SHINE MEDICAL TECHNOLOGIES, INC.

**SHINE MEDICAL TECHNOLOGIES, INC. APPLICATION FOR CONSTRUCTION PERMIT
RESPONSE TO REQUEST FOR ADDITIONAL INFORMATION**

**PRELIMINARY SAFETY ANALYSIS REPORT CHANGES
(MARK-UP)**

Figure 9a2.1-1 – **RVZ4RCA Ventilation System** Flow Diagram
(Sheet 1 of 2)

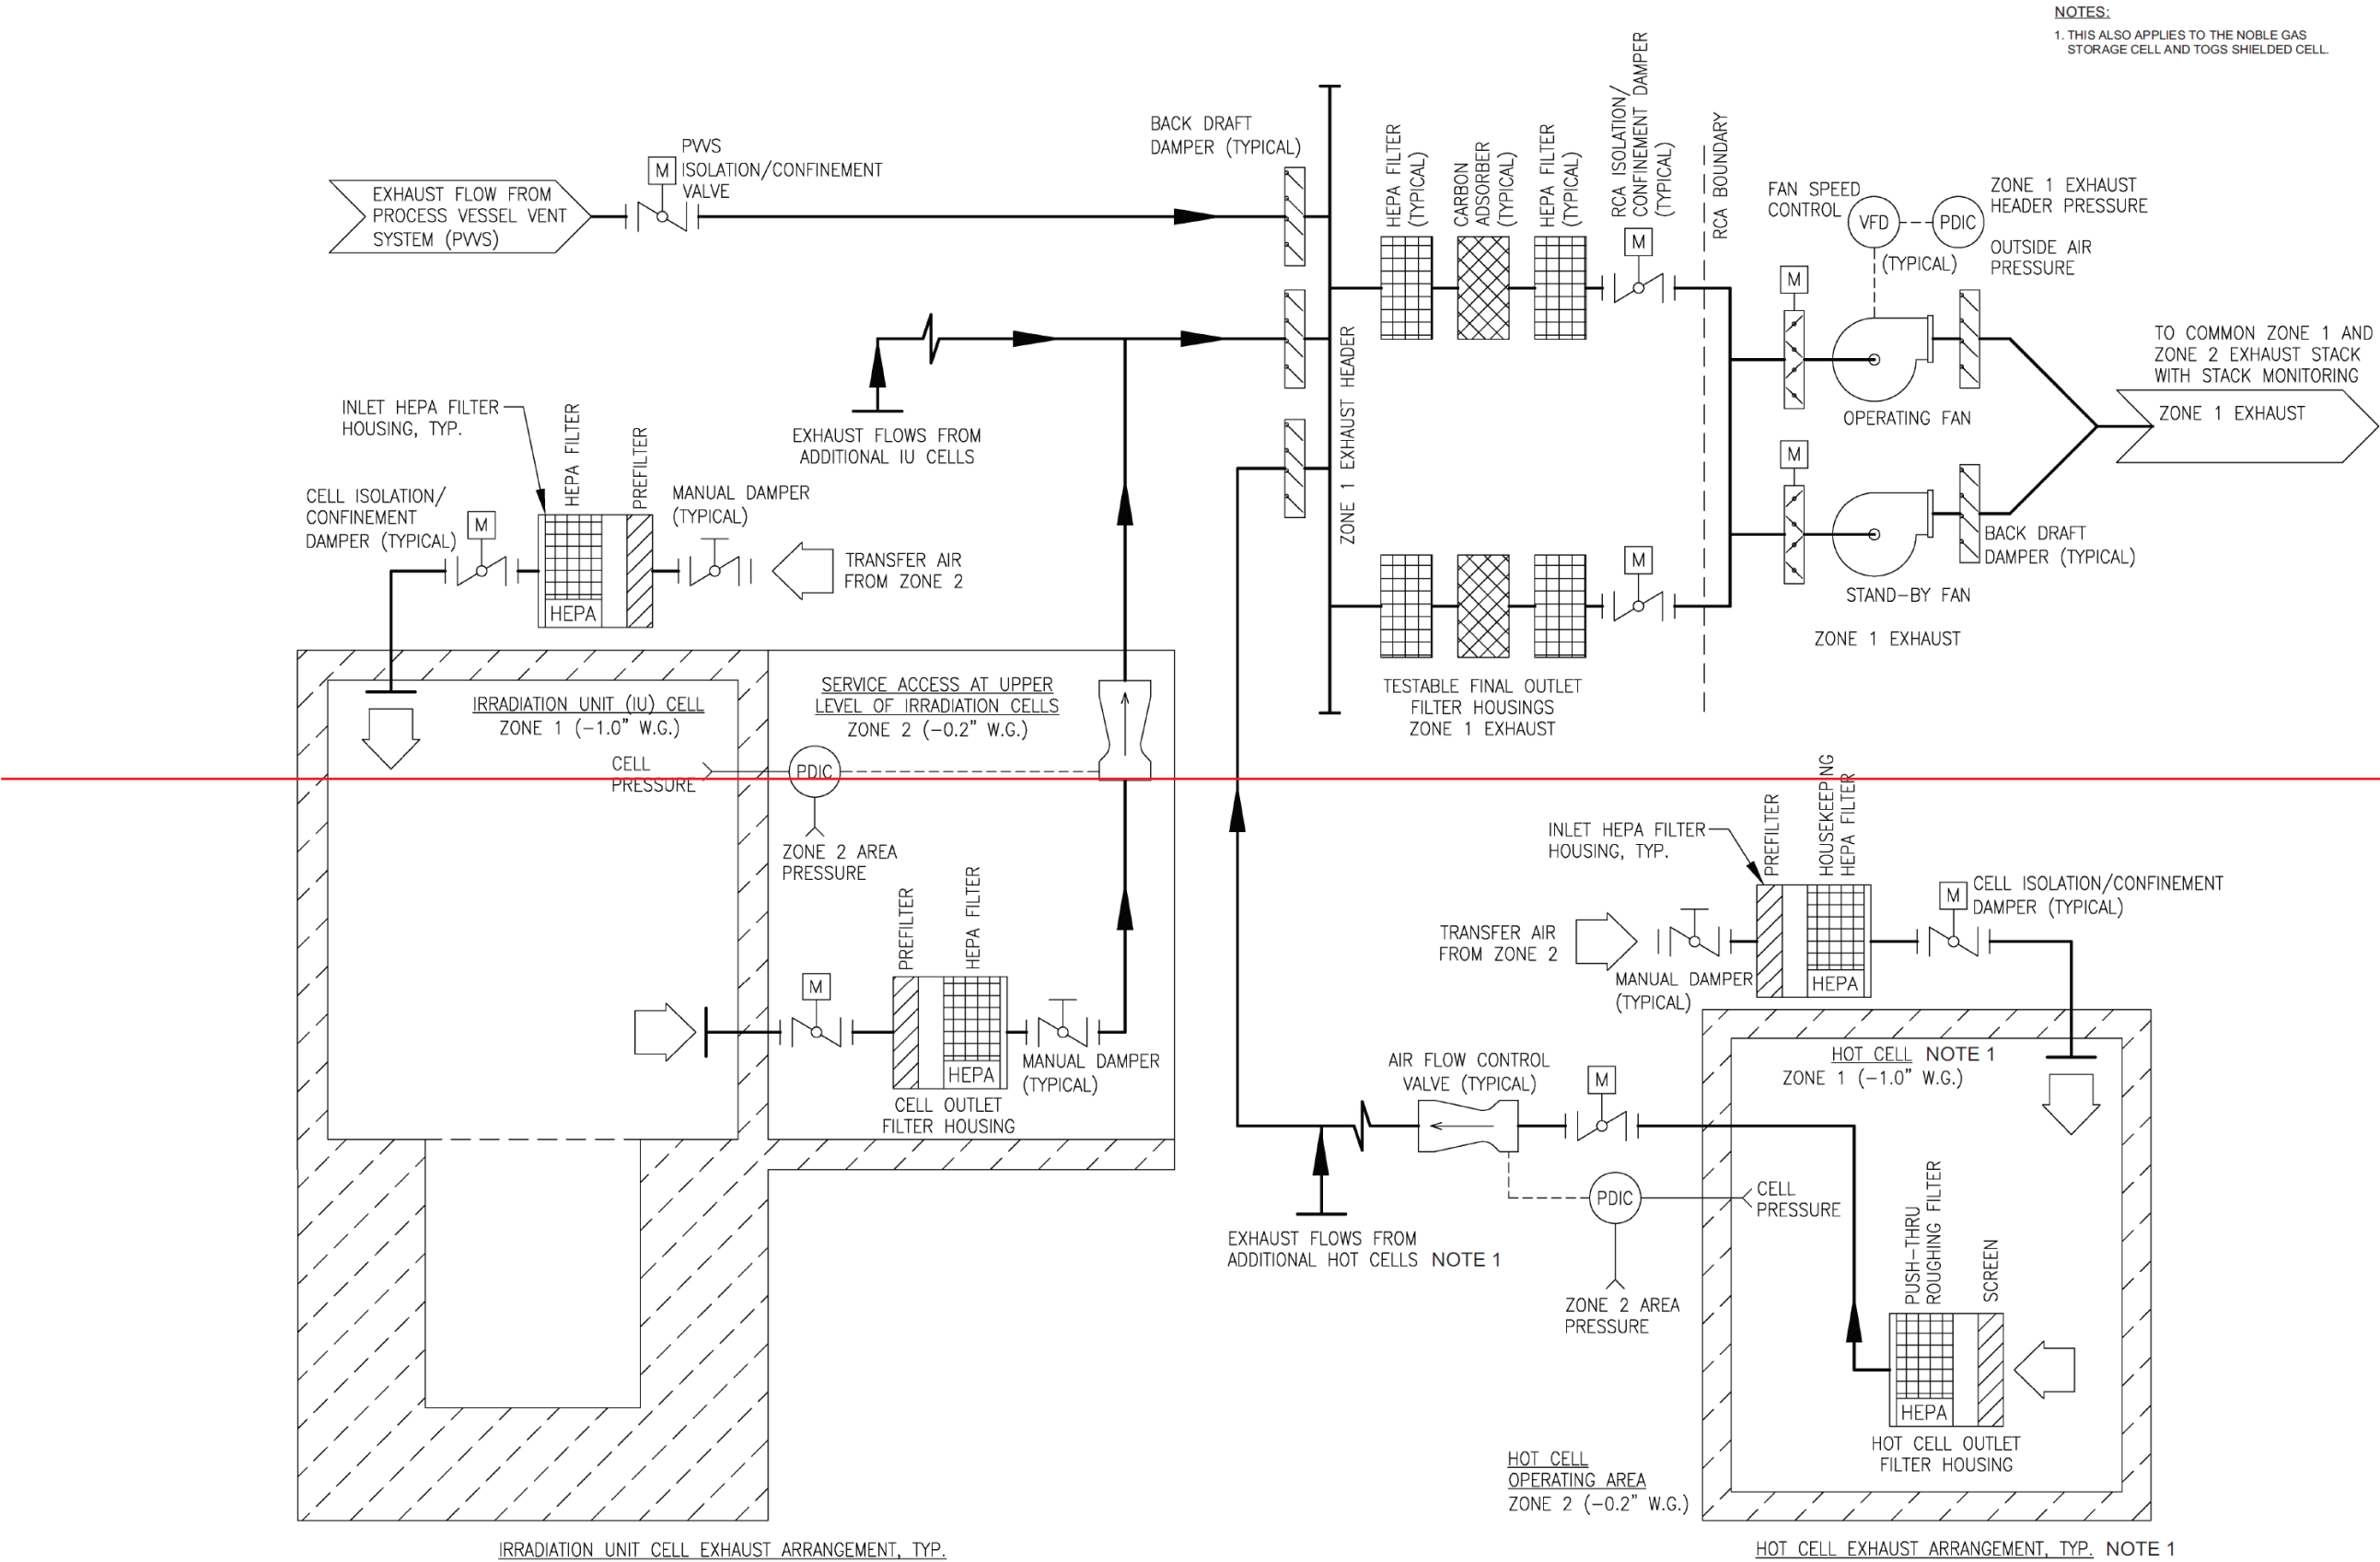
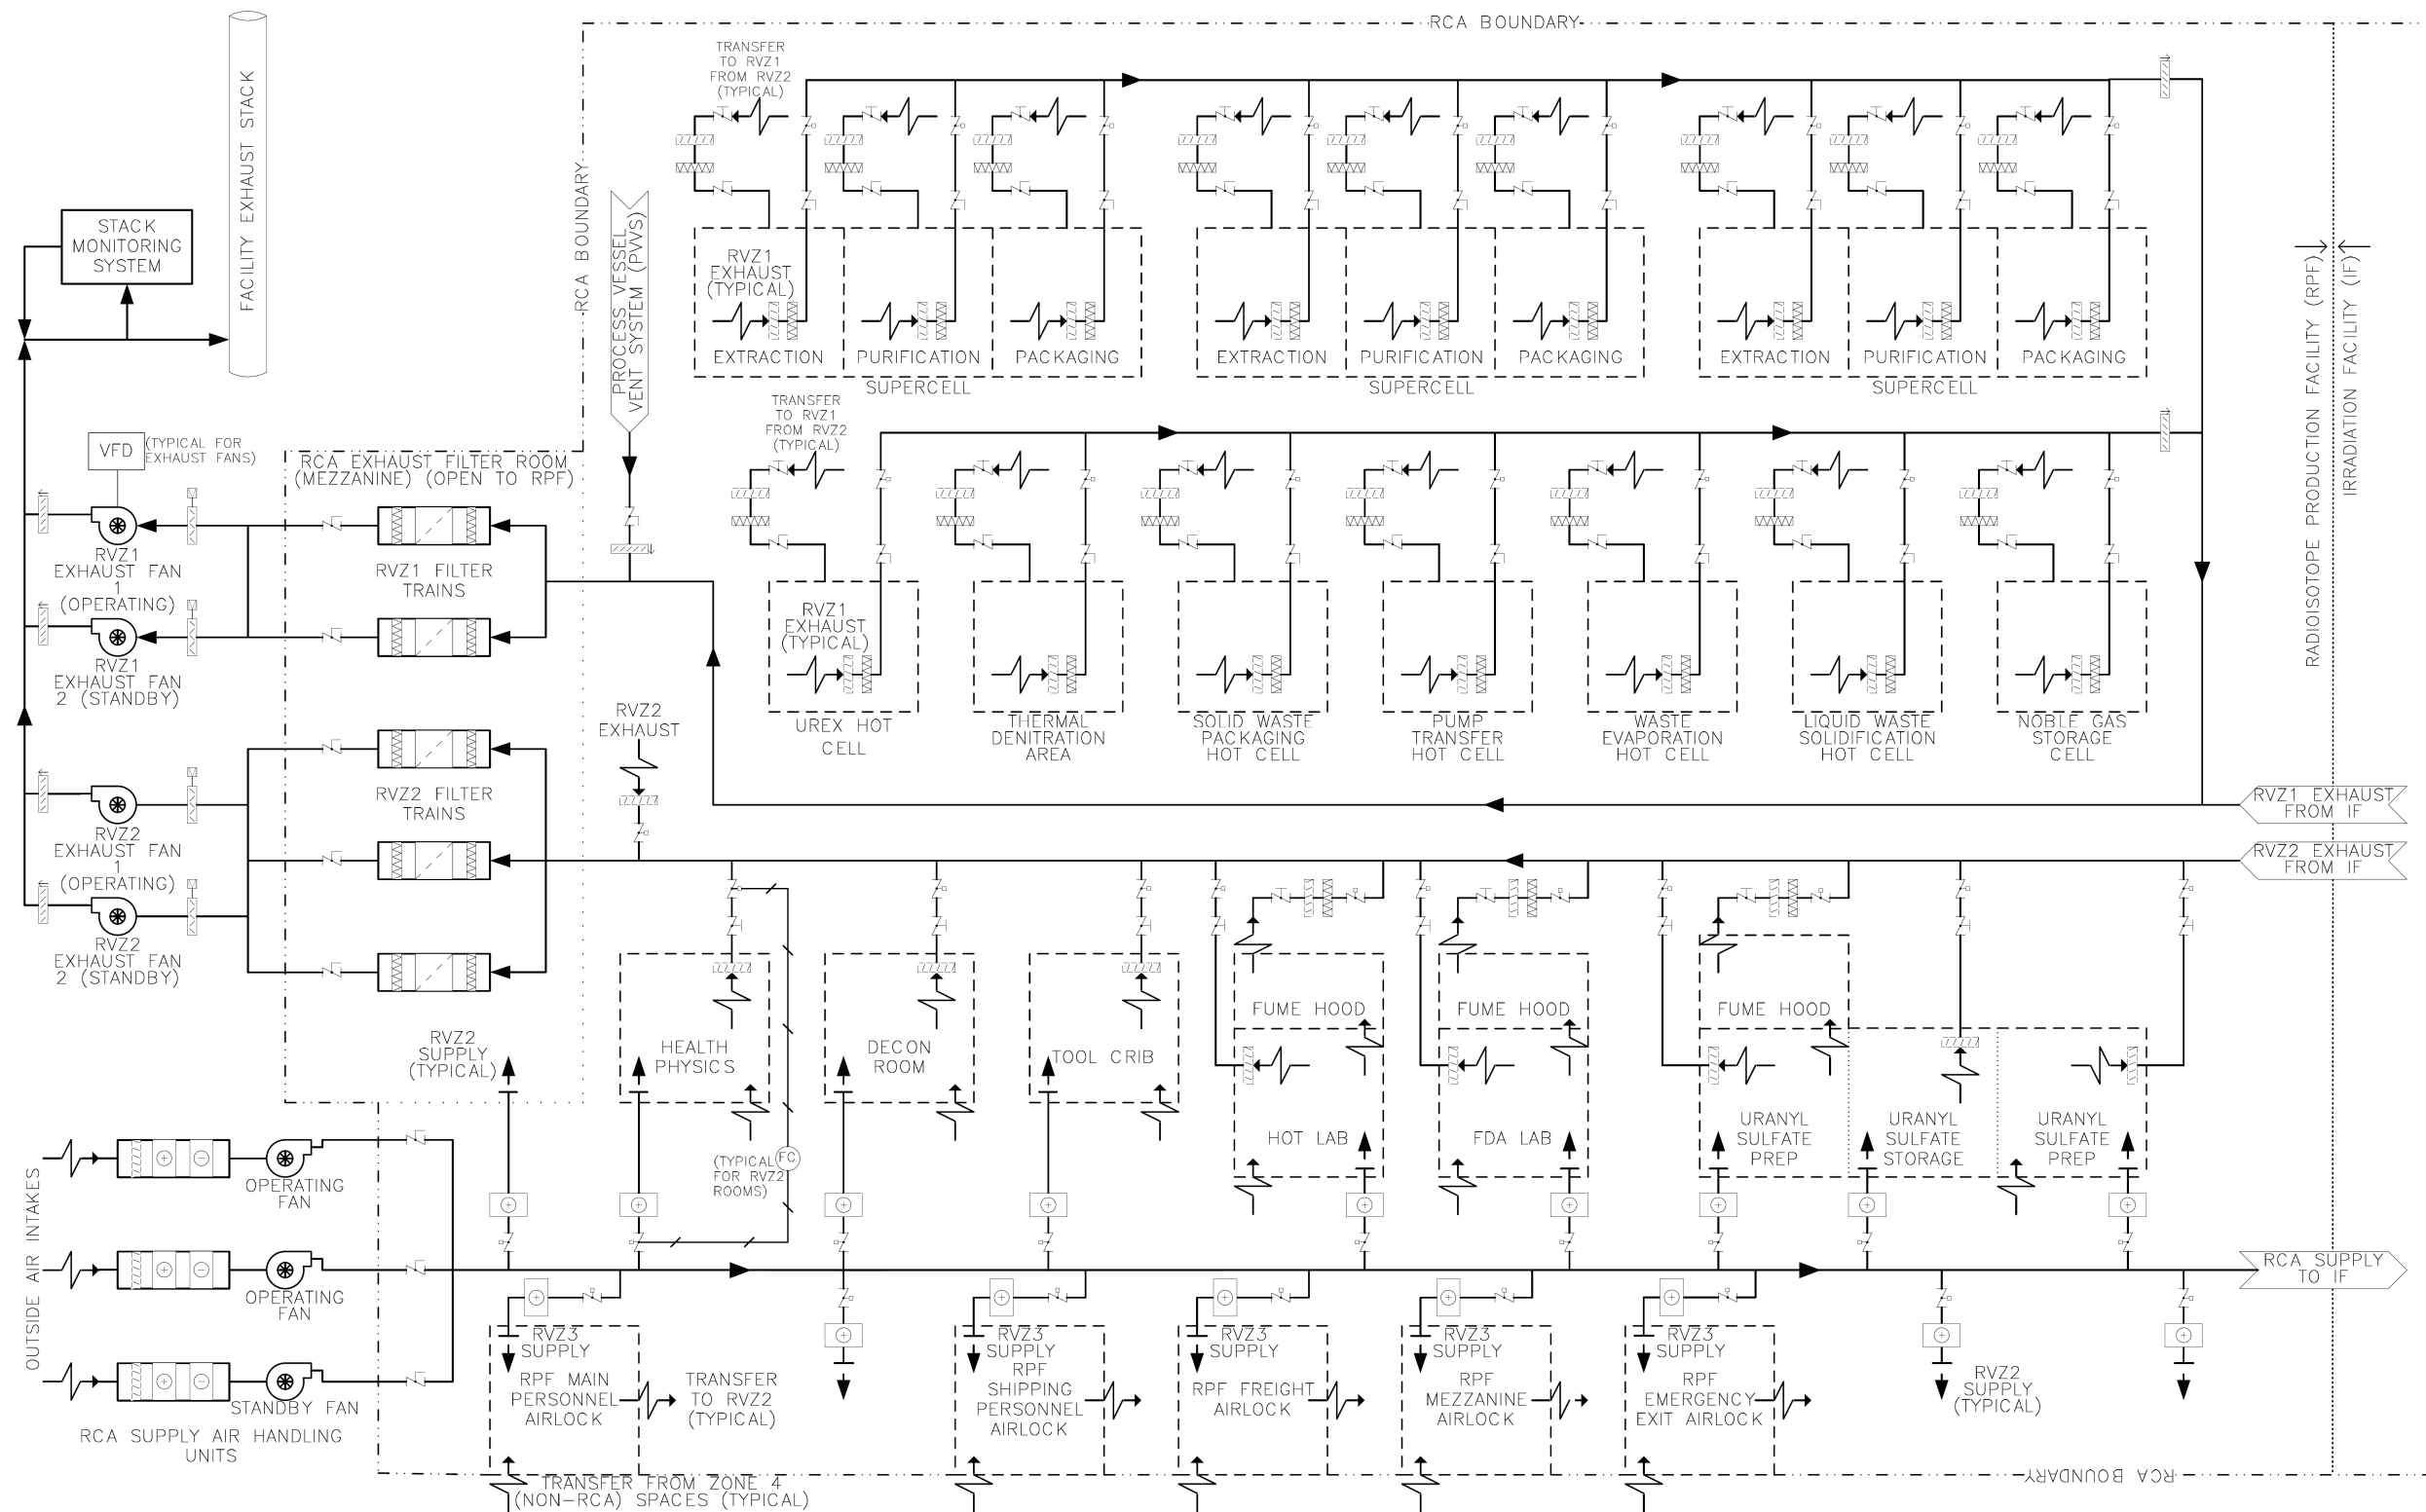
A Ventilation flow diagrams are is provided in Figures s 9a2.1-1 and 9a2.1-2 (the legend for process flow diagrams is provided on Figure 1.3-6).
